I-4 Truck Parking Facilities (447724-1)

Value Engineering Study Final Report

FM Number: 447724-1

Project Description: I-4 Truck Parking Facilities

RECOMMENDATION No. 8B: Eliminate the entrance/exit on the Sand Lake Road ramp

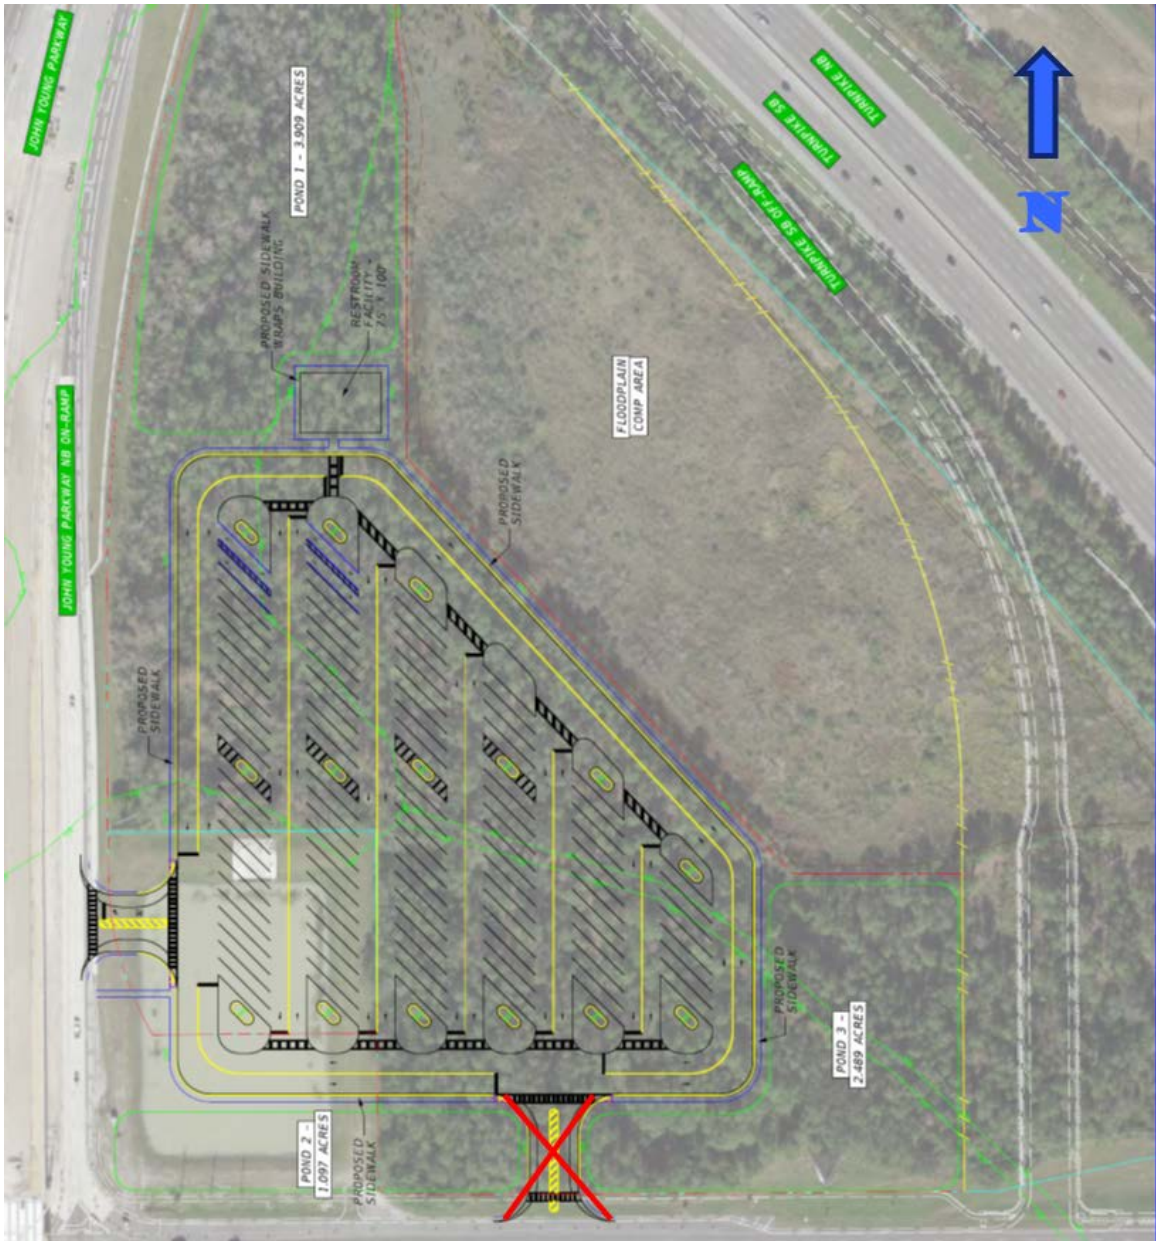
The PD&E Documents show ingress/egress on both John Young Parkway and Sand Lake Road.

RECOMMENDATION No. 18: Reconsider the control vehicle for the Seminole County Site

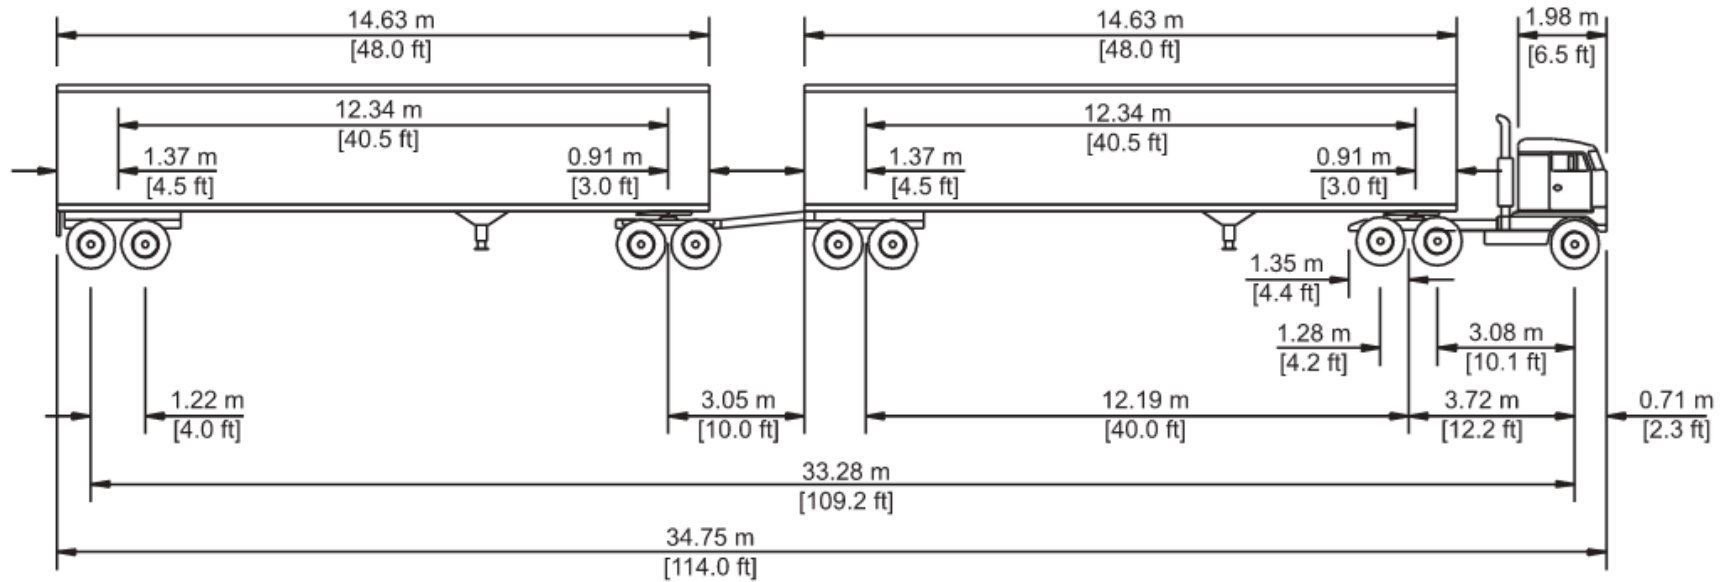
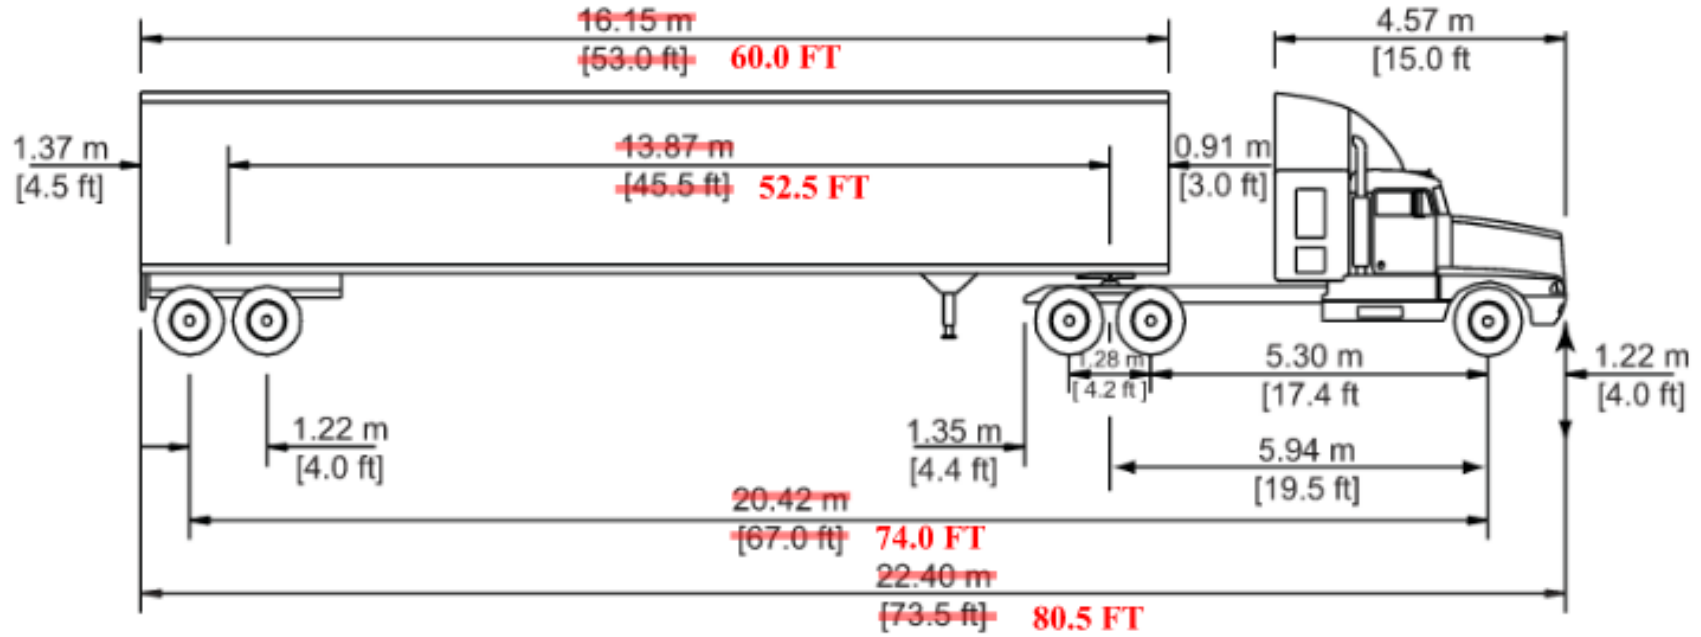
The Design Documents show the accommodation of a WB-109D tractor-trailer circulating the site and utilizing the oversize parking spaces. The spaces accommodating extended length loads maintaining the parking space width of 15 feet. The two-way circulation lanes are currently shown at 50-ft in width.

The VE team recommends using a modified WB 67 tractor-trailer vehicle for the oversized vehicle control vehicle. Extending the standard WB-67 tractor-trailer from 67 feet to 74 feet would accommodate a more reasonable oversize load anticipated to use the site. Superloads would not look to navigate tight configuration sites for parking during non-permitted hours. The current control vehicle (WB-109D) is commercially authorized to be used only on the Florida Turnpike Enterprise (FTE) roadway. The change in the control vehicle will provide the ability to reduce 1,200 feet of two-way circulation lanes from 50-ft to 42 ft. in width. This will result in a net reduction of 1,067 SY of asphalt, optional base, stabilization, and an average of 2-ft of embankment.

Response: Accepted

The VE Recommendation is to change the vehicle used as the oversized control vehicle from a WB-62FL to a modified WB-67 tractor-trailer.

The site layout was based on the WB-62FL and WB-67D to provide sufficient travel way widths appropriate for "average driver skill", and to provide two-way traffic along three sides of the site for recirculation, and to access the mobile repair vehicle and windshield wash. The WB-109D design vehicle was used only to confirm that the vehicle could access the site if this vehicle were to be routed onto I-4. The use of this vehicle results in minor modifications to island radii only. The WB-109D is limited in the number of on-site routes that would not require multiple maneuvers. The modified WB-67 tractor trailer can access and maneuver the site with fewer on-site routes that require multiple maneuvers.

The recommendation is accepted. However, after the revised site layout was reviewed the use of the modified WB-67 tractor trailer does not reduce the site footprint or yield additional parking sites.

RECOMMENDATION No. 19: Re-purpose the existing building at the northern end of the property

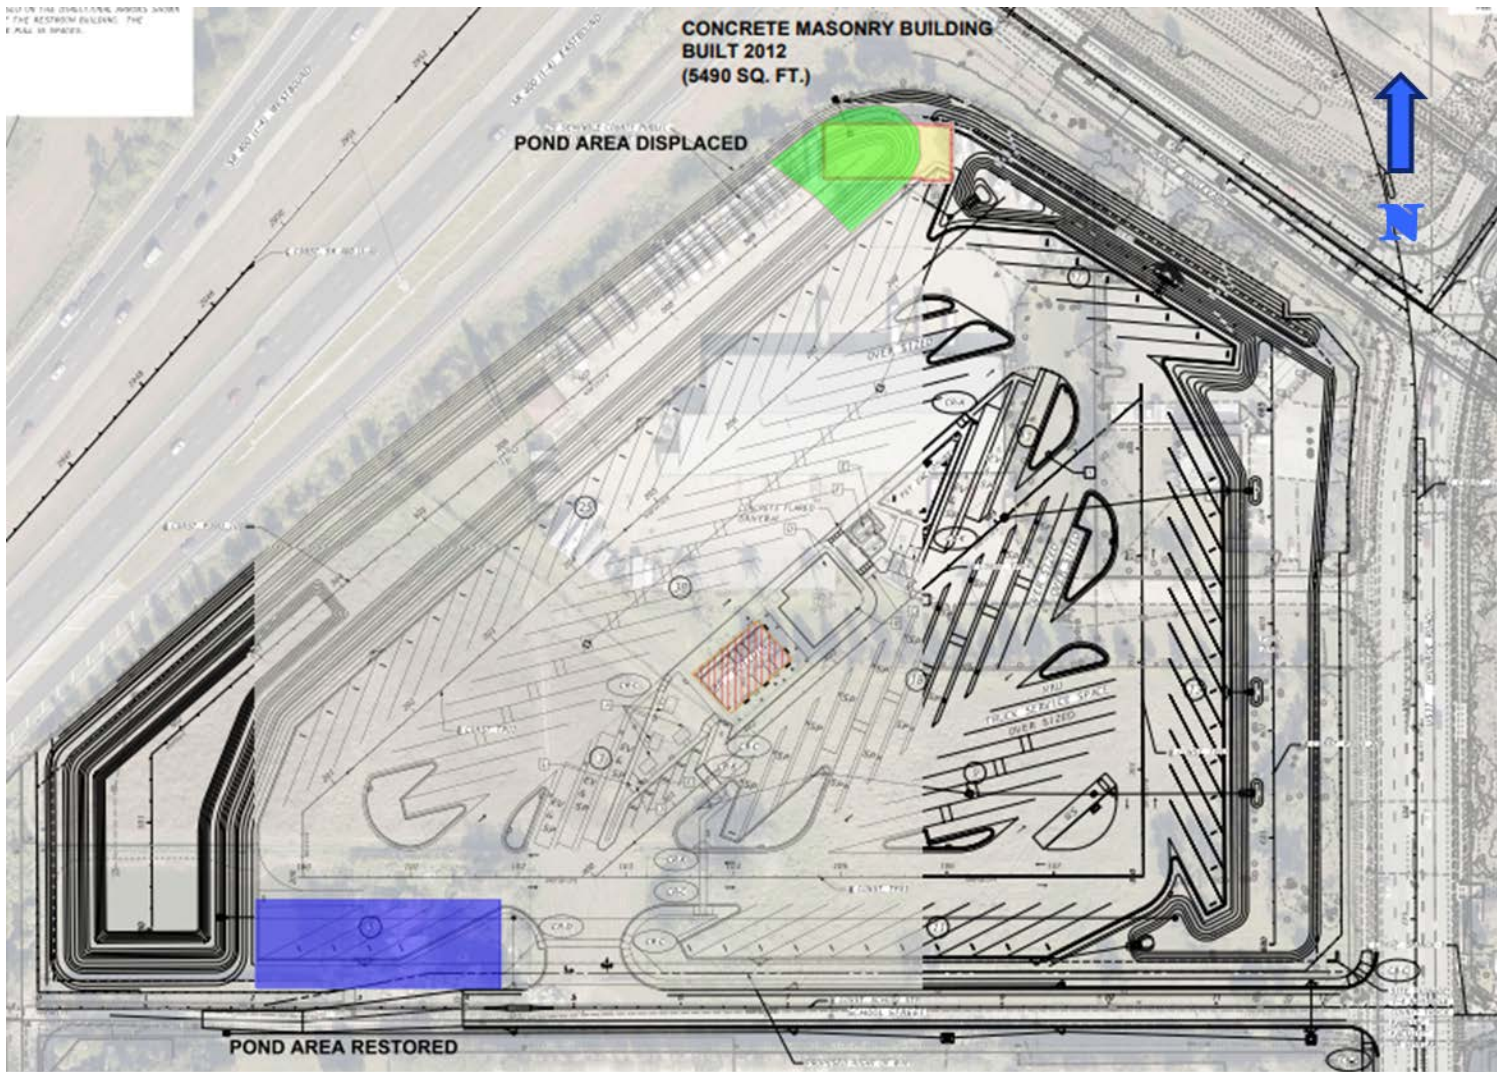
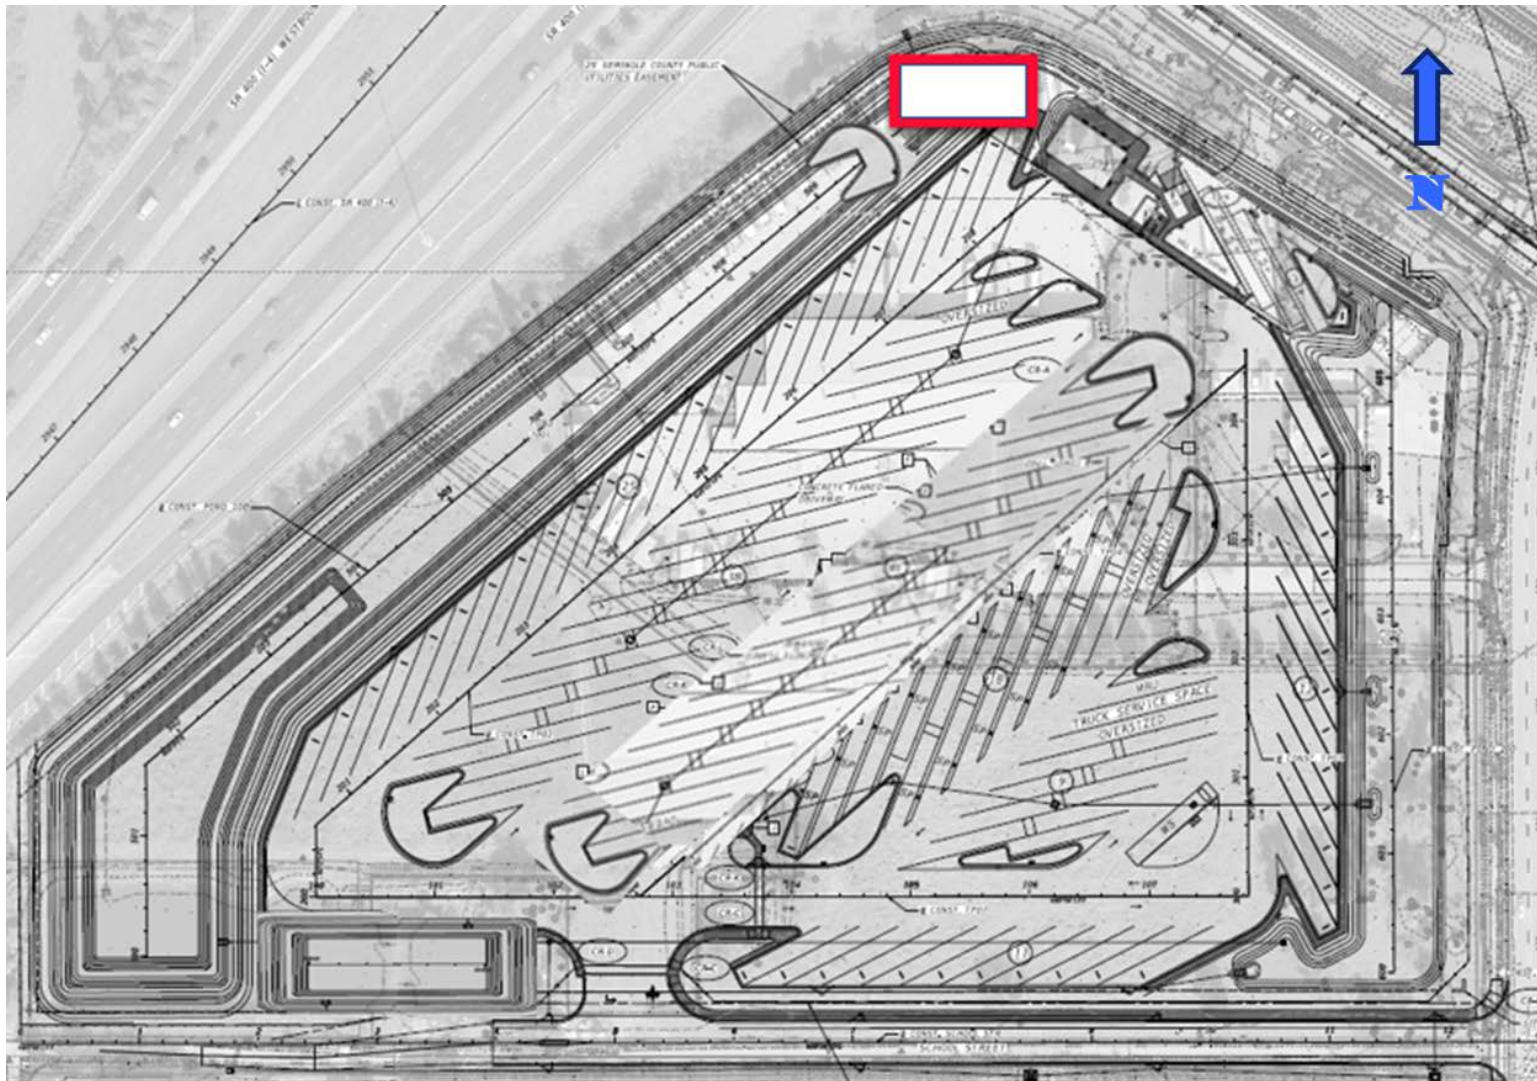
The PD&E Documents show a total site area of 18.69 acres with a total of 132 truck parking spaces. The existing site includes several buildings which are planned to be razed to accommodate the proposed facility. The PD&E shows a proposed restroom building providing men’s and women’s facilities as required according to the number of parking spaces proposed. The building will also include a unisex bathroom, a security office, and a vending area.

VE Recommendation #19: Repurpose Existing Building (Seminole County Site 1)**Potential Cost Savings: \$2,086,000****Response:** Not Accepted

This VE Recommendation proposes repurposing one of the existing buildings on the Donnie Myers property to accommodate the required restrooms, security, and vending facilities. The existing floor plans would need to be obtained, along with any previous modifications, in order to determine the extent of modifications required to retrofit the building for the new use. Utility rerouting is anticipated due to current utility locations. Therefore, potential cost savings or additional construction cost are unknown.

The building is also not centrally located on the site, which is the preferred location based on trucking industry input. The existing building has a floor elevation beneath the current design's proposed pond maintenance berm. Modifying the pond to provide the same treatment and attenuation volumes would require a decrease in the number of parking spaces. Using this building would necessitate redesigning the site and would result in a decrease in the number of parking spaces.

RECOMMENDATION No. 24 and 30 (Volusia site EB and WB)

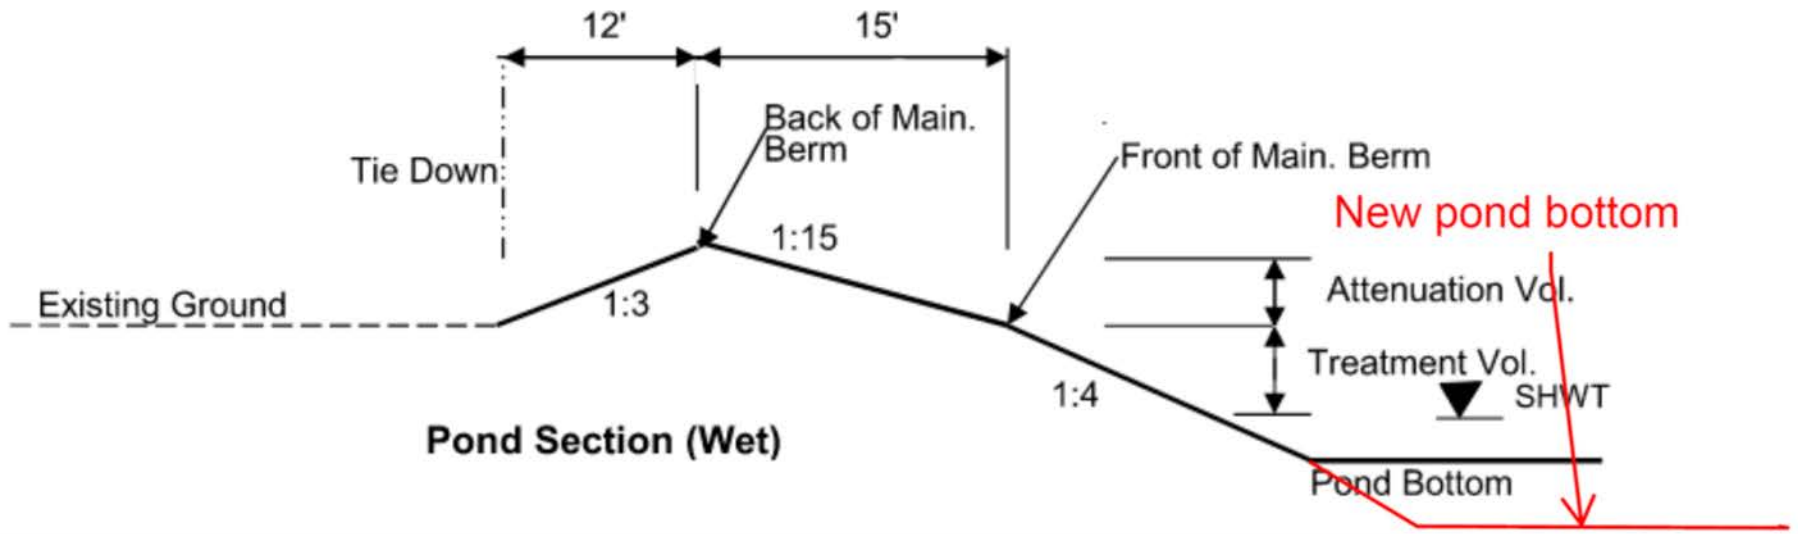
The PD&E Documents show a large amount of fill being trucked to the site.

The VE team recommends utilizing existing fill on site. One way this can be done is by digging the ponds 2' deeper to provide additional fill. (Assume 75% of excavation is usable)

Response: Add to List of Design Suggestions

The VE Recommendations propose increasing the depths of the proposed pond for each site by 2' in order to provide additional fill that can remain on site during the construction phase of the sites, thereby reducing construction cost. A Design phase survey will be required in order to determine the amount of fill that can remain on each site, and therefore the cost benefit of these recommendations. These recommendations will be added to the list of design suggestions.

VE Resolution: *FDOT agreed this recommendation should be added to the list of design suggestions.*

RECOMMENDATION No. 32: Enlarge the existing pond to the west and reduce the pond on the east side of the site (includes ideas 26 and 27)

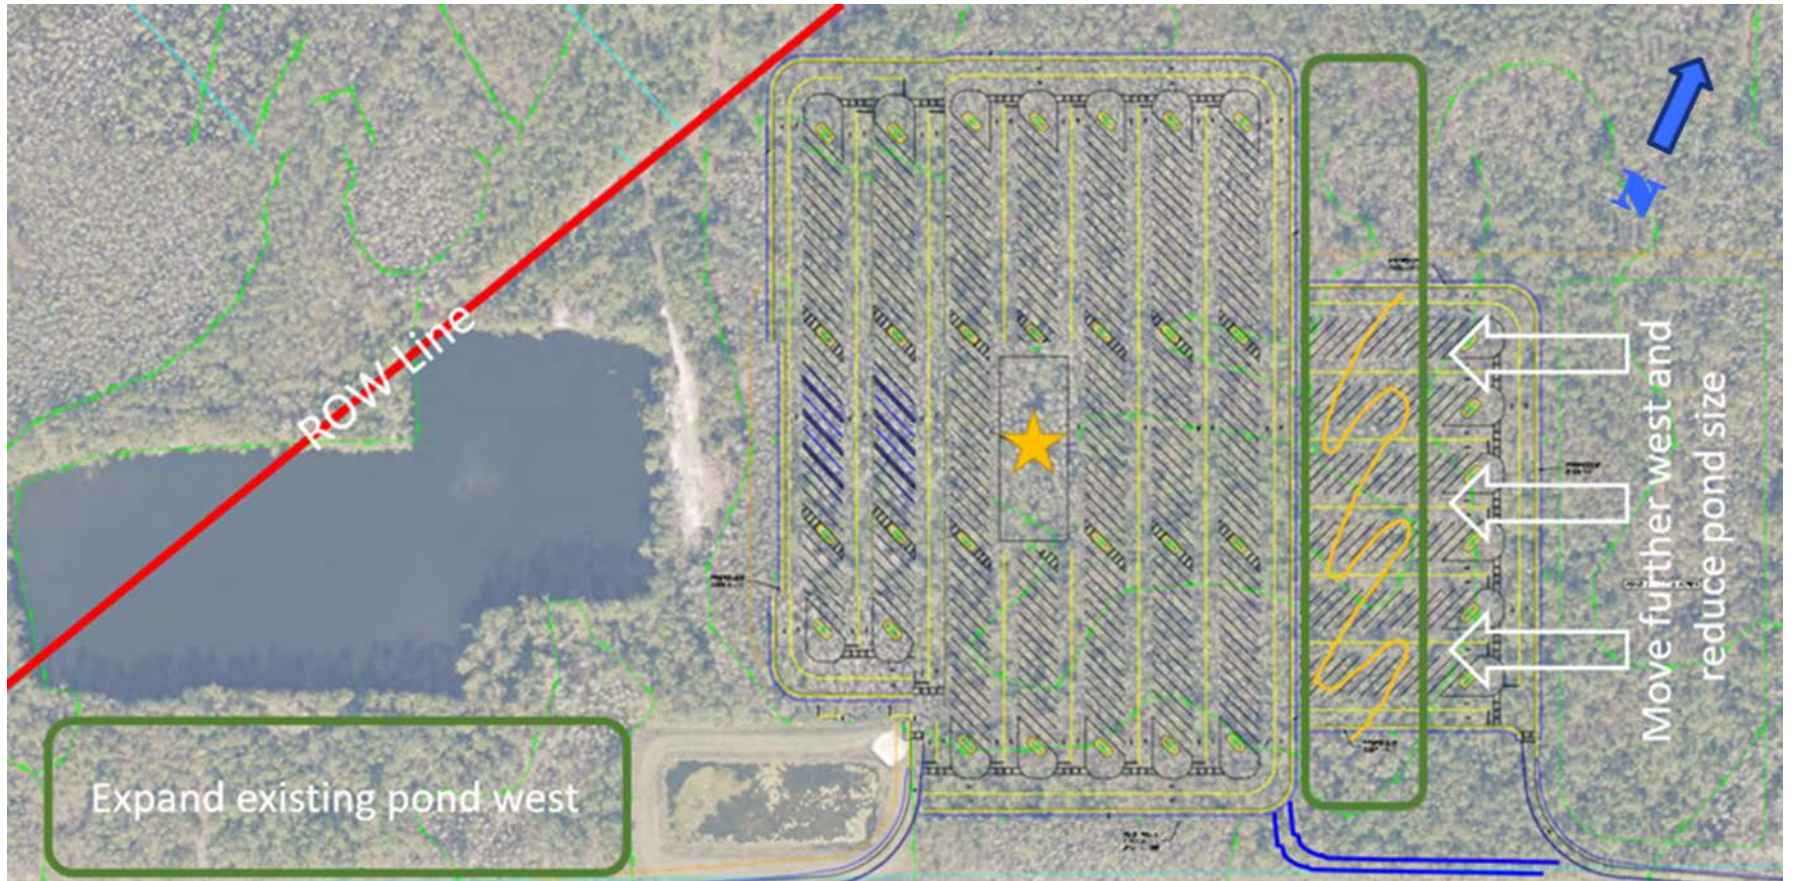
RECOMMENDATION No. 32: Enlarge the existing pond to the west and reduce the pond on the east side of the site (includes ideas 26 and 27)

Response: Accepted

The VE Recommendation proposes a revised site layout for Volusia County Site 1B to combine and centralize the restroom (consistent with **VE Recommendation #1C**), rotate the site 90 degrees, widen the existing pond abutting the west end of the westbound on-ramp, add an additional parking row to the west side of the site, and reduce the size of the pond to the east.

The PD&E Study team redesigned the concept plan for Volusia Site 1B and determined that rotating the site 90 degrees increases the number of available parking spaces from 253 to 267 (14 additional spaces). This recommendation also increases the size of the wildlife corridor and moves the entrance ramp farther away from the existing wildlife crossing.

The recommendation is accepted with the condition that two adjacent back-in parking rows are provided to create the necessary room for the recommended centralized 100' x 270' restroom. Locating the restroom facility between only one parking row allows for only a 64' wide restroom facility. The cost savings for the centralized restroom is included in Recommendation #1C. This VE Recommendation results in a slight increase in cost due to additional impervious related to the additional spaces and minor additional pavement and fencing due to rotating the site. However, this revised concept enhances wildlife connectivity and is recommended for incorporation.
